3 Volt Intel[®] Advanced+ Boot Block Flash Memory

28F800C3, 28F160C3, 28F320C3, 28F640C3

Specification Update

Order Number: 297938-014

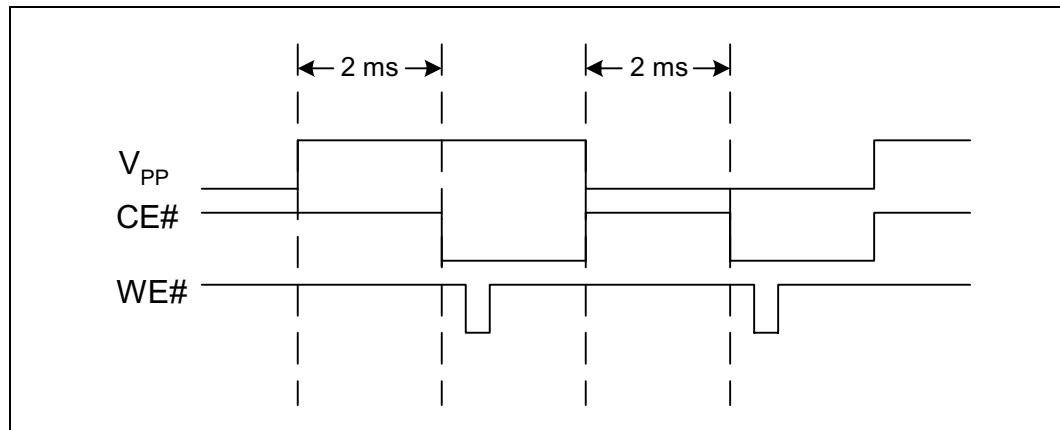
Problem: The 0.18 μ m 28F320C3xC devices can unintentionally reset under certain conditions where V_{pp} toggles.

Implication: When the reset occurs, any command being executed is interrupted and the flash switches to read array mode.

- 1) Tie V_{pp} to V_{CC} ;
- 2) If the third and fourth digits on the top side FPO mark (third line) is equal or greater than “23”, then V_{CC} may be set from 2.7v to 3.3v. V_{CC} must not exceed 3.3v
- 3) Set V_{pp} to a static high or static low level as shown here; and

4) Wait 2 ms after a V_{PP} transition to access the flash device, as shown here.

Figure 1. Workaround Placement

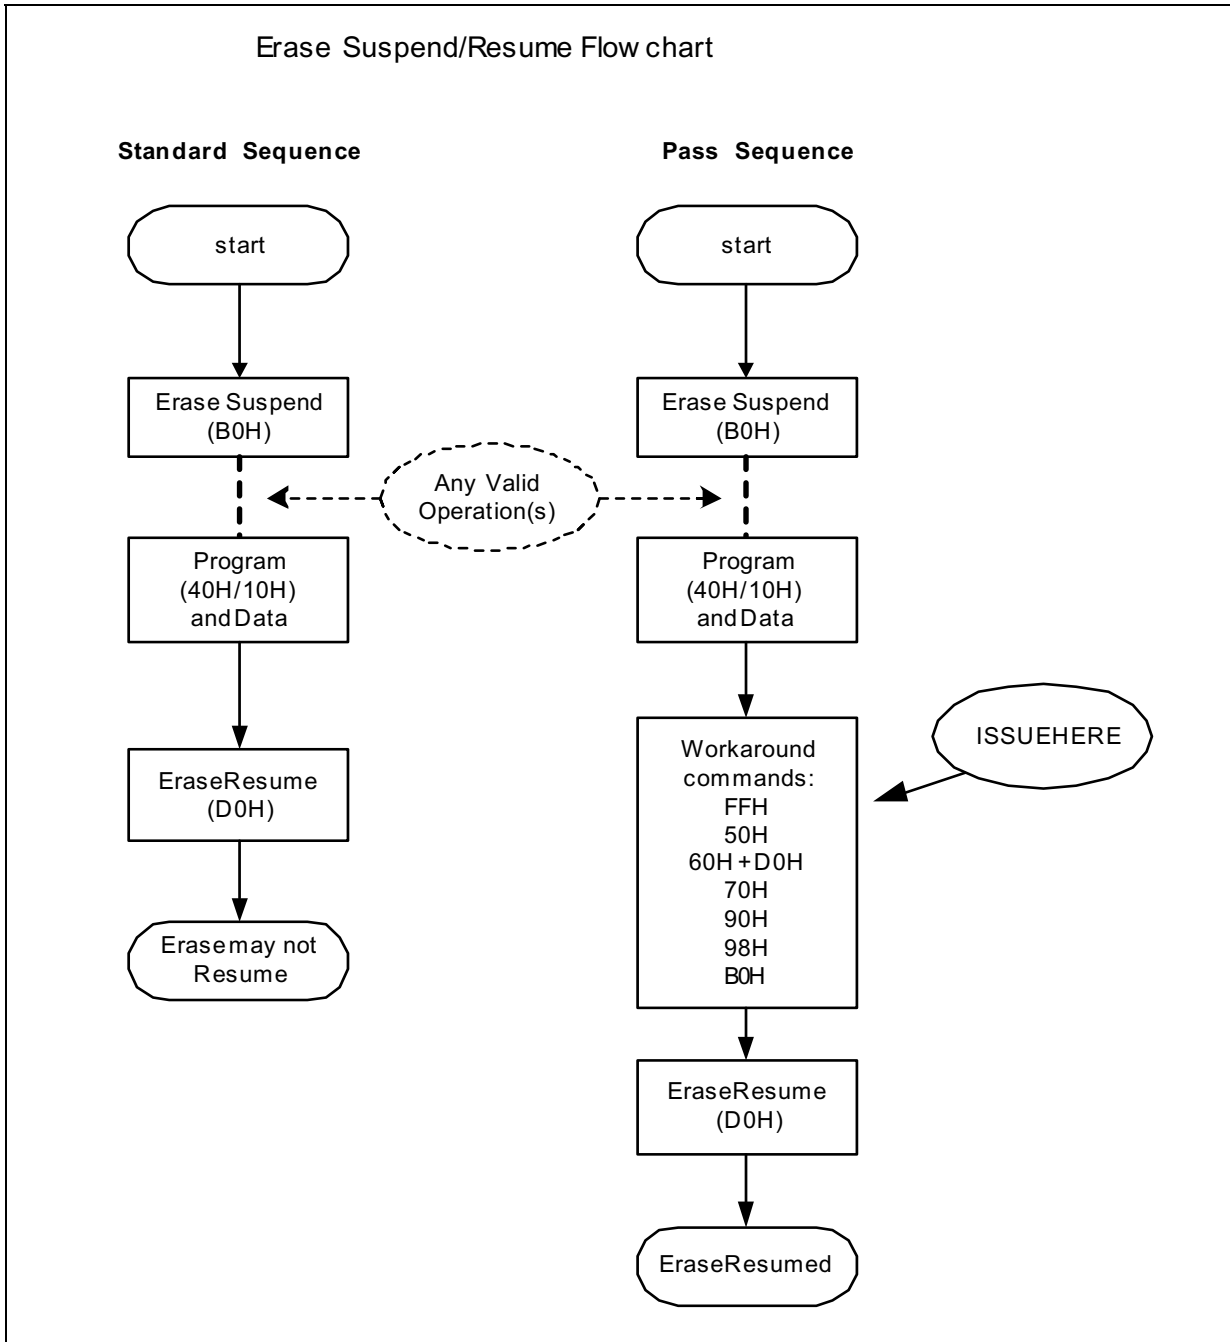
Problem: On the 0.18µm 28F160C3xC devices, a design anomaly was discovered. During an Erase-Suspend operation, if the Program (40H/10H) sequence is executed, under limited conditions the proceeding Erase Resume command (D0H) may not actually resume the device. No customers have reported failures in product applications. Customers who use any version of FDI (Intel Flash Data Integrator) software will not see this issue. If the Read Array command is issued prior to the Erase Resume command, users will not see the issue (typical in XIP applications).

Implication: The Resume Command (D0H) may be ignored by the device and will not correctly resume. The device will appear to remain in suspend (via status register). After a reset of the flash device the status register will clear. This failure has been recreated in a lab environment only.

1. If FDI (Intel Flash Data Integrator) software is used, users will not see the issue.
2. During an Erase-Suspend (B0H), user must issue any of the following commands after issuing the Program (40H/10H) and data sequence but before issuing the Erase-Resume (D0H) command.

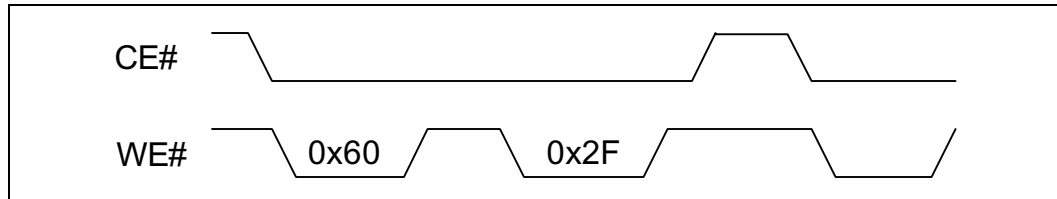
Problem: On the 16Mb and 64Mb 0.18µm devices, if CE# is deasserted after any block lock operation and before the next write sequence, the part may perform the same operation on additional blocks. (See waveform below.)

Implication: When CE# is deasserted after performing a block lock operation to a specific block and prior to the next write sequence, other blocks may perform the same operation.
